Remarks

Drawings

Amendments to the Drawings

FIG. 2
(PRIOR ART)

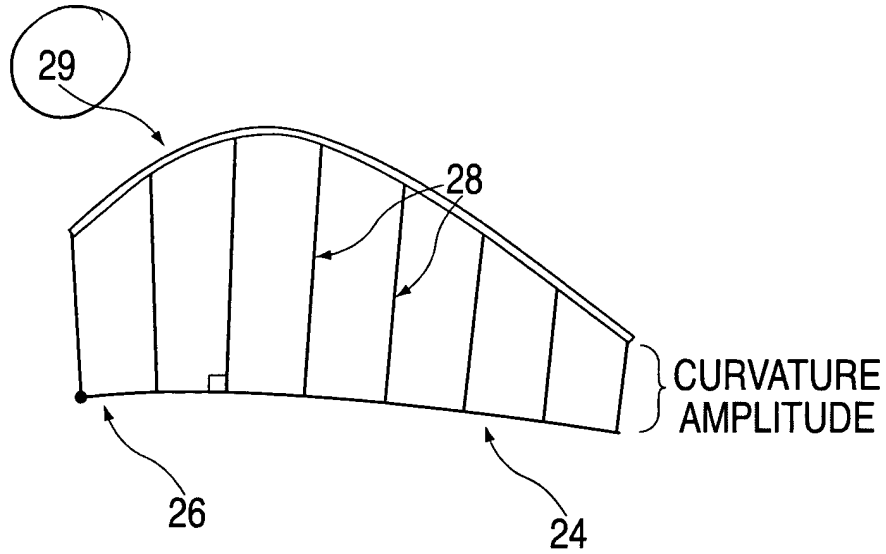
In Fig. 2, the reference numeral 30 has been replaced by the numeral 29. An amendment providing a corresponding change to the specification has also been made in this Response.

Was "30"

FIG. 3

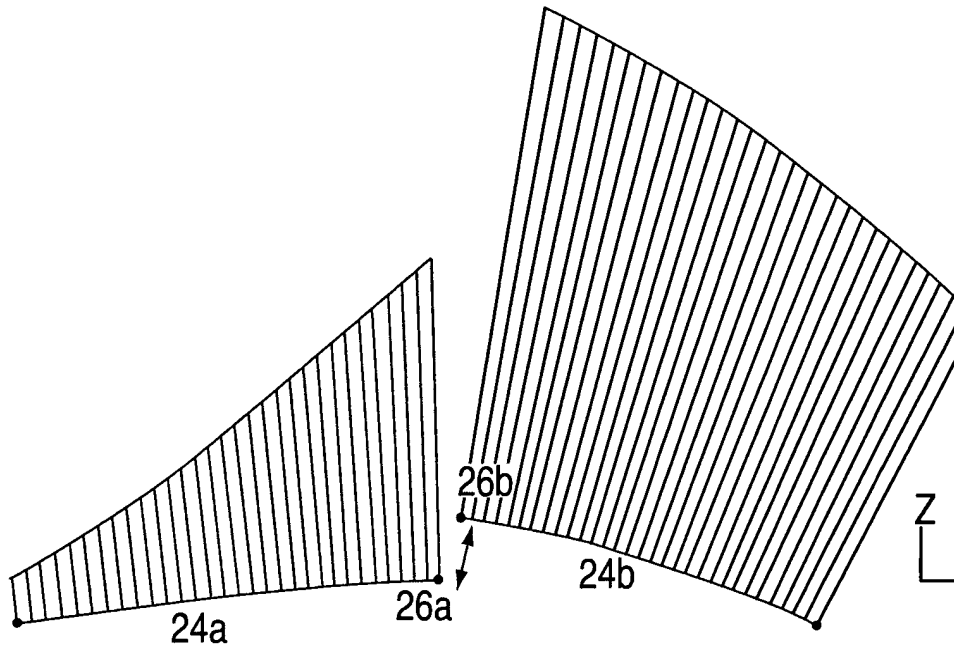
Figs. 2 through 14 have been changed to fix shading and color errors presented in the original drawings.
